FACPAC Contract Change Order

Tier 1 Project: CHHS Phase 2

CHANGE ORDER NUMBER: 3-4
INITIATION DATE: 12/12/2025

**AIA**[®]**Document G709[™] – 2018****Proposal Request**

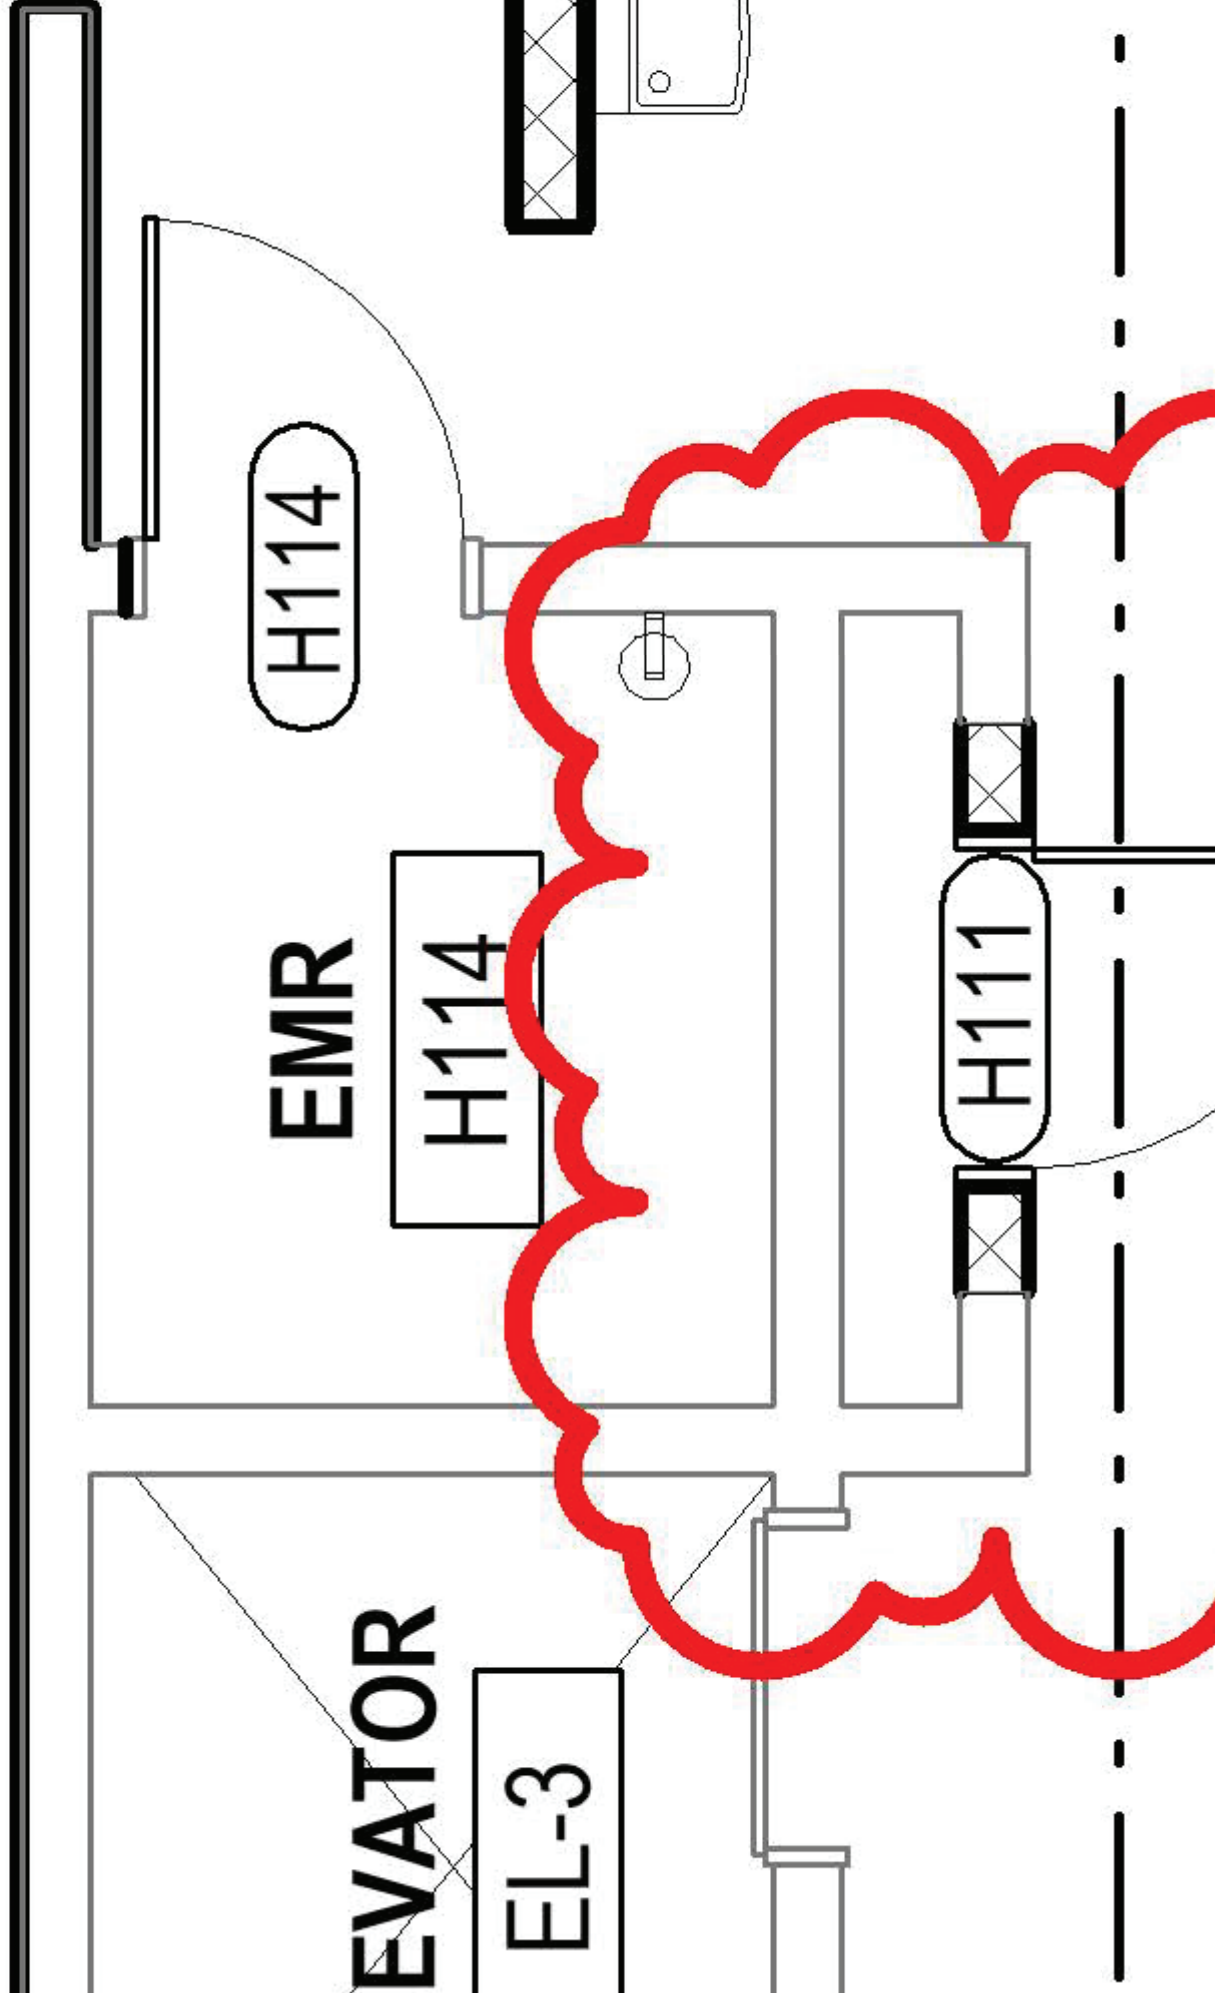
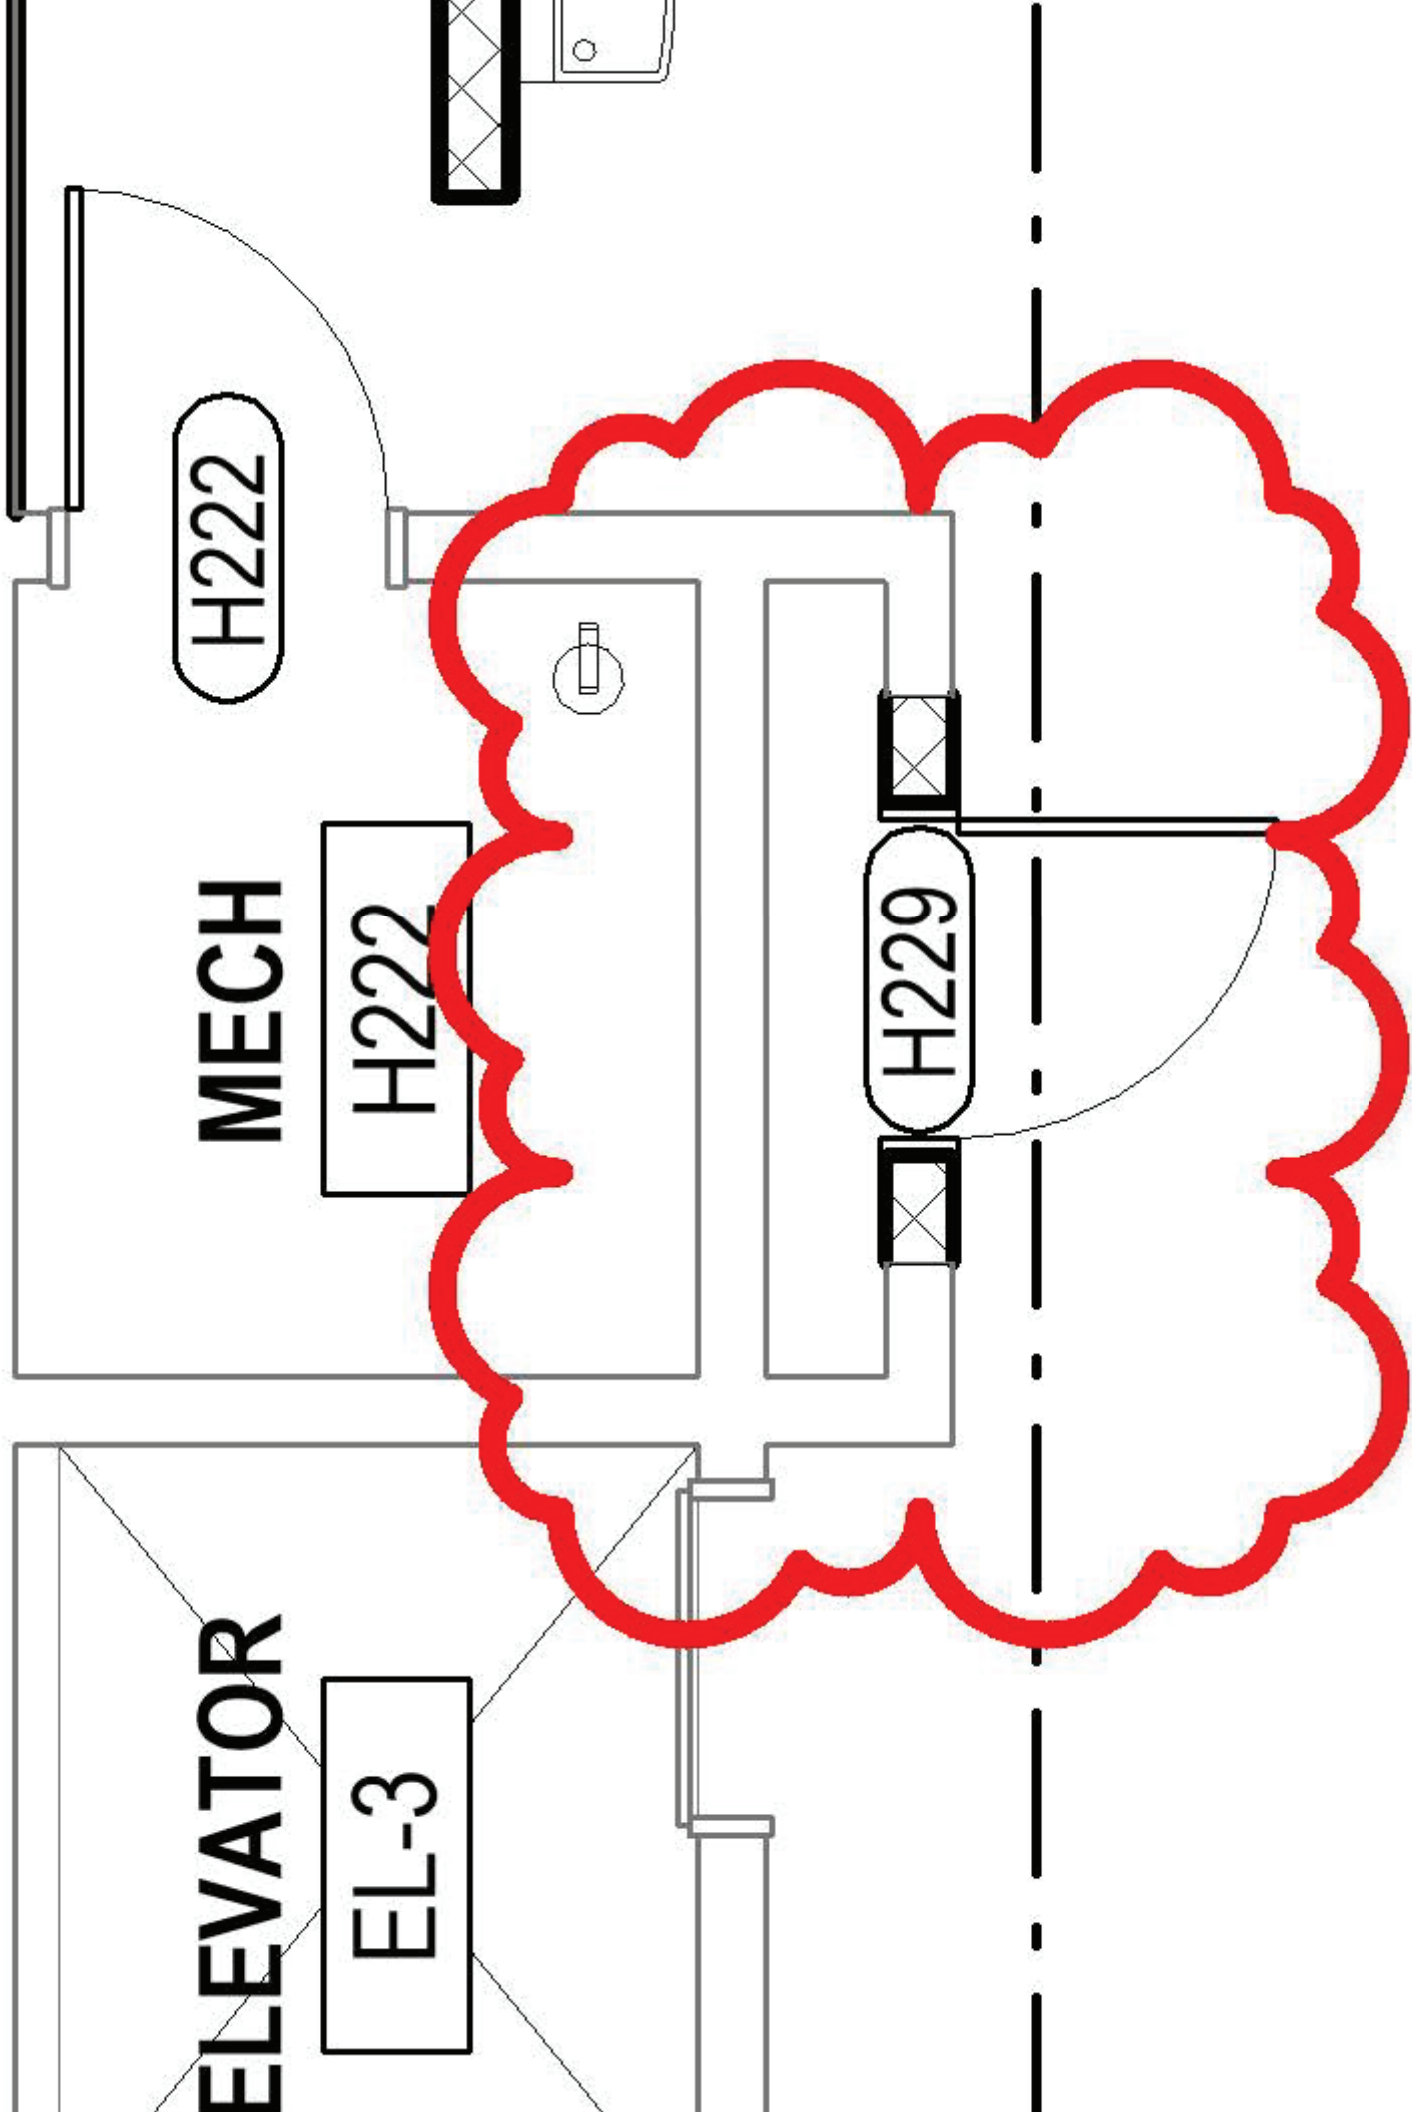
The owner would like to remove 2 display cases and turn them into closets.

Provide pricing for demolition of the sliding window, CMU below and bottom of display case. Provide a 3'-0" by 7'-2" single "Type F" wood door with hollow metal frame.

Match door hardware on H215A door. Infill with CMU as required.

Match adjacent finishes and paint interior of room P-1, add B-1 rubber base, RT-1 rubber flooring and add light fixture.
